# Access Compliance Report

## Public Rights-of-Way

Intersection ID: 5464	Main Street: OAK_DR	Cross Street: WANAMASSA_DR	Location: S
ADA ID: 17FB4A259E84	Ramp Type: Perp	Initial Pass/Fail: Fail	Overall Compliance: No
Severity Score: 22.5			
Codes/Mitigation Info/Possible Solution		Field Measurements/Component Compliance

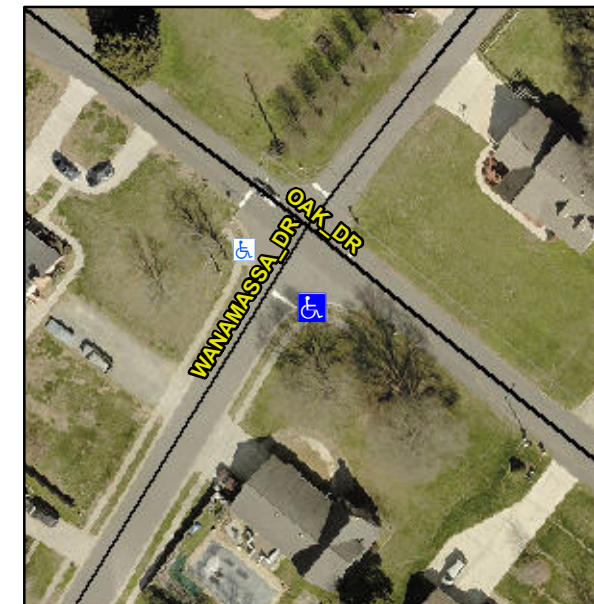
**R304.5.1, R304.2.2, R304.5.3**

Compliance	Description	Data	Compliance	Description	Data
N/A	Ramp Length (in)	49.5	No	Ramp Slope (%)	9.8
No	Ramp Width (in)	47.0	No	Ramp XSlope (%)	2.5
N/A	Flare Type LT	N/A	N/A	Flare Type RT	N/A
N/A	Flare Slope LT (%)	N/A	N/A	Flare Slope RT (%)	N/A
N/A	Flare Traversable LT?	N/A	N/A	Flare Traversable RT?	N/A
N/A	Landing Length (in)	N/A	N/A	DWS Provided?	N/A
N/A	Landing Width (in)	N/A	N/A	DWS Contrast?	N/A
N/A	Landing Slope (%)	N/A	N/A	DWS Length (in)	N/A
N/A	Landing X Slope (%)	N/A	N/A	DWS Full Width?	N/A
N/A	Landing Curb? (Y/N)	N/A	N/A	DWS Offset (in)	N/A
N/A	Shared Landing?	N/A			
N/A	Gutter Ponding?	N/A	N/A	Gutter Slope (%)	N/A
N/A	Gutter Lip Ht (in)	N/A	N/A	Gutter X Slope (%)	N/A
N/A	Painted X Walk1?	No	N/A	Painted X Walk2?	N/A
	X Walk 1 Direction	To W		X Walk 2 Direction	N/A
N/A	X Walk 1 Width (in)	N/A	N/A	X Walk 2 Width (in)	N/A
	X Walk 1 Slope (%)	1.7		X Walk 2 Slope (%)	N/A
	X Walk 1 X Slope (%)	1.1		X Walk 2 X Slope (%)	N/A

**Remove & Replace Entire Ramp.**
